**DATE:** June 23, 2016

**SUBJECT:** **Petition PB-16-34 SUP:** Greenberg Farrow (John Vecchio, P.E.) agent for Walmart Stores East, owner. A special use permit with an intermediate development plan to allow for the construction of a gas station with convenience store. Zoned: MU-2 (12—30 units/acre mixed use medium intensity). Located at 1800 NE 12th Avenue.

<b>PETITION NO.</b> <b>PB-16-34 SUP</b>	<b>DATE PLAN RECEIVED:</b> 04/19/2016	<b>REVIEW TYPE:</b> <input checked="" type="checkbox"/> Prelim Dev <input checked="" type="checkbox"/> Final Dev <input type="checkbox"/> Amendment <input type="checkbox"/> Special Use <input type="checkbox"/> Planned Dev <input type="checkbox"/> Design Plat <input type="checkbox"/> Concept <input type="checkbox"/> Minor Dev. <input type="checkbox"/> Minor Sub. <input type="checkbox"/> Street Vacation <input type="checkbox"/> Other: Land Use
<b>REVIEWING BODY:</b> Technical Review Cmt.	<b>REVIEW DATE:</b> 05/02/2016	
	<b>REVIEW LEVEL:</b> N/A	
<b>PROJECT DESCRIPTION:</b> <u>Petition PB-16-34 SUP</u> Greenberg Farrow (John Vecchio, P.E.) agent for Walmart Stores East, owner. A special use permit with an intermediate development plan to allow for the

DRAWN BY: DJF  
DATE: 02-25-16  
**15049**  
LANDSCAPE PLAN  
**L1.0**

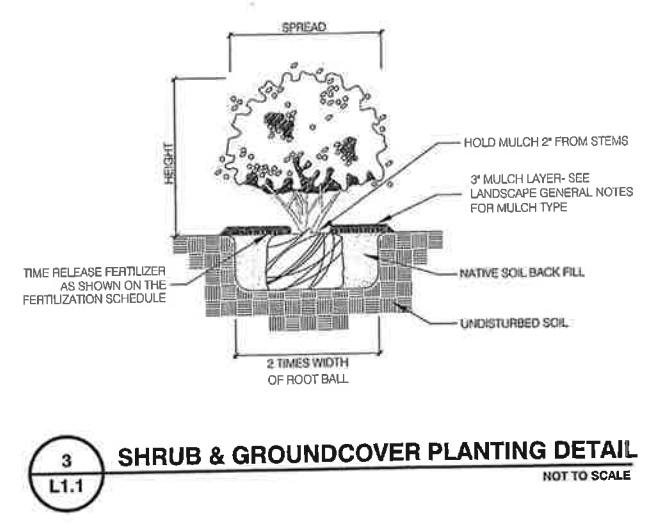
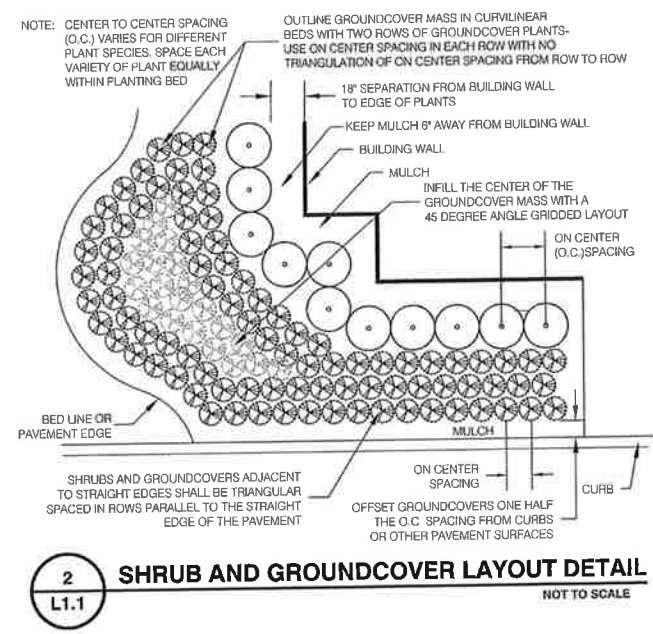
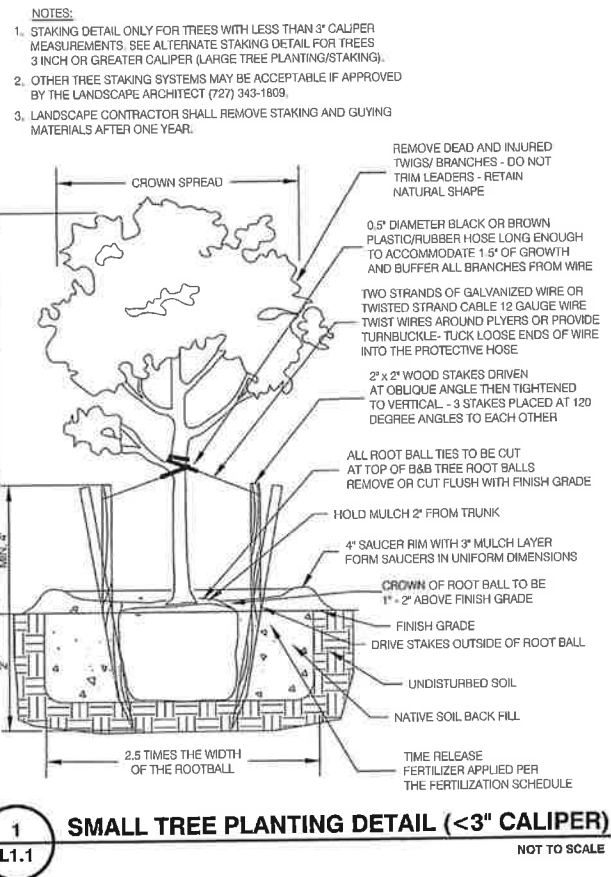
7. It appears that the landscaping provided along the exterior of the vehicular use area may create a safety concern because of its height. Staff recommends a species that would be shorter and provide less screening.

1. Please replace the Red Maple trees with Florida Maple trees.

**1 PHOTOMETRIC SITE PLAN**  
SCALE: 1"=30'-0"

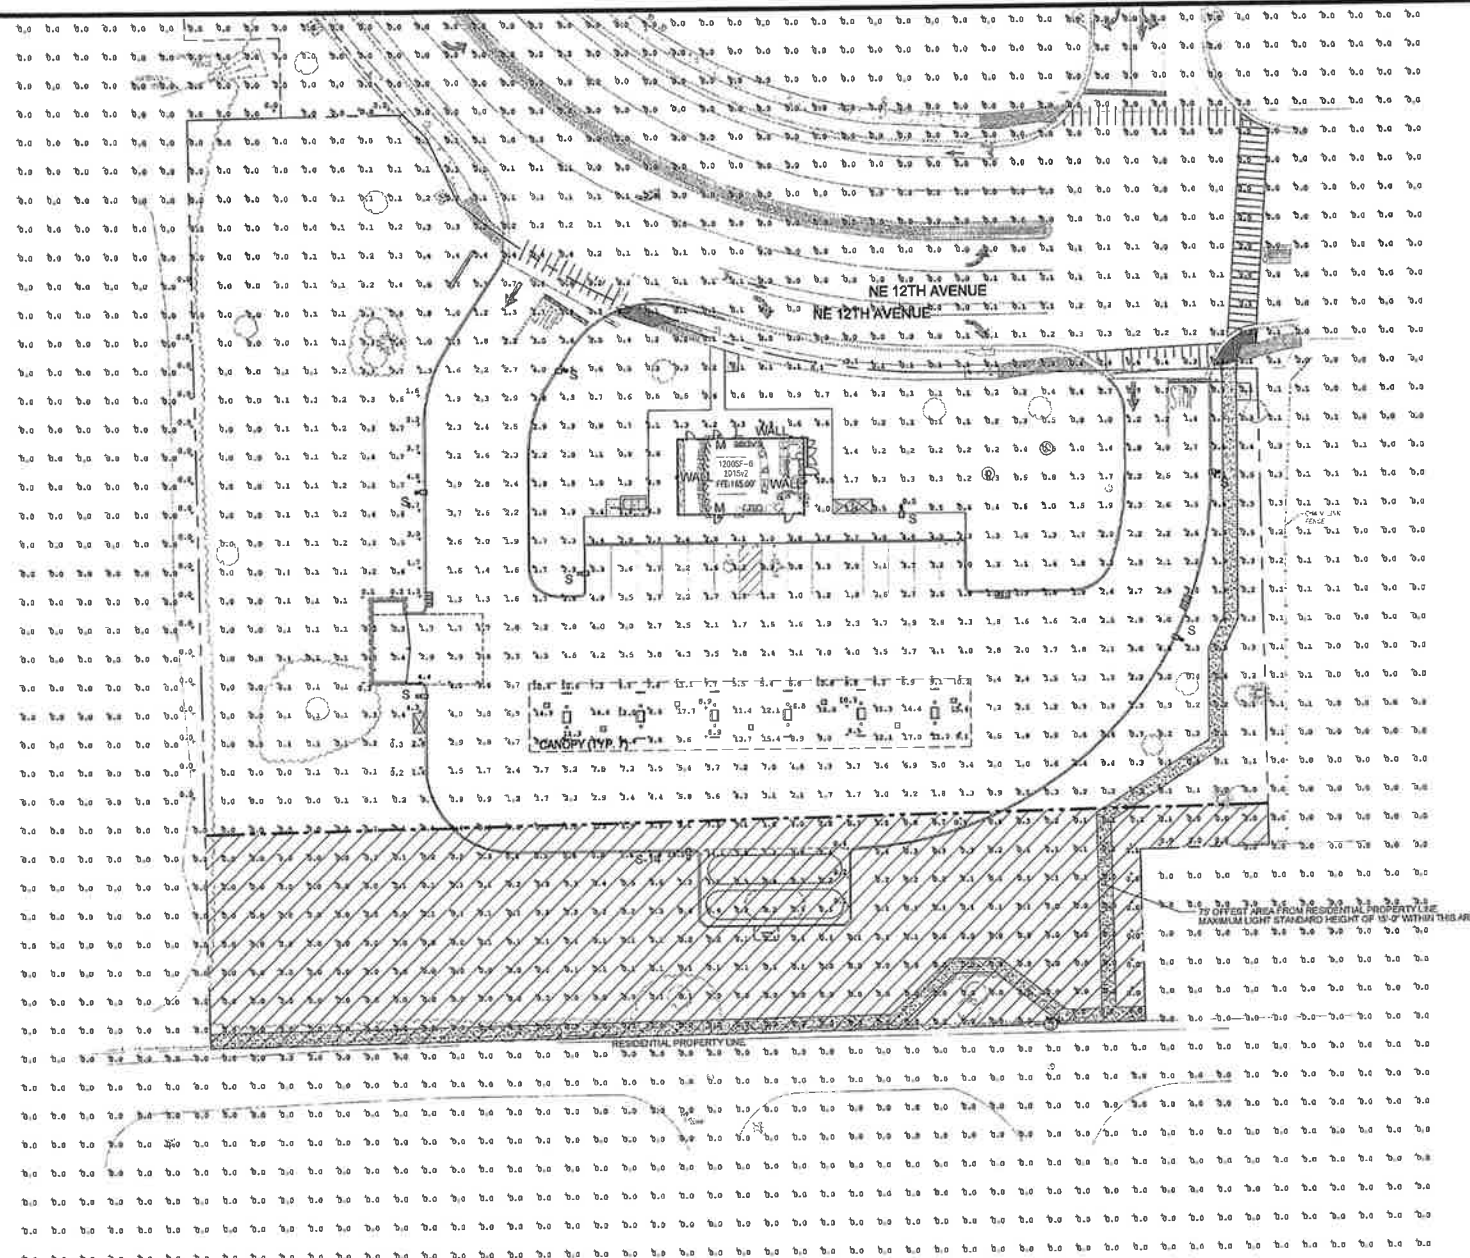
***Condition 4. The photometric plan shall ensure that lighting complies with the requirements of the Land Development Code. Consideration of any waivers shall not allow lighting intrusion and spillover lighting into the adjacent neighborhoods. All light fixtures shall be designed and placed so that there is no direct lighting into the adjacent neighborhoods.***
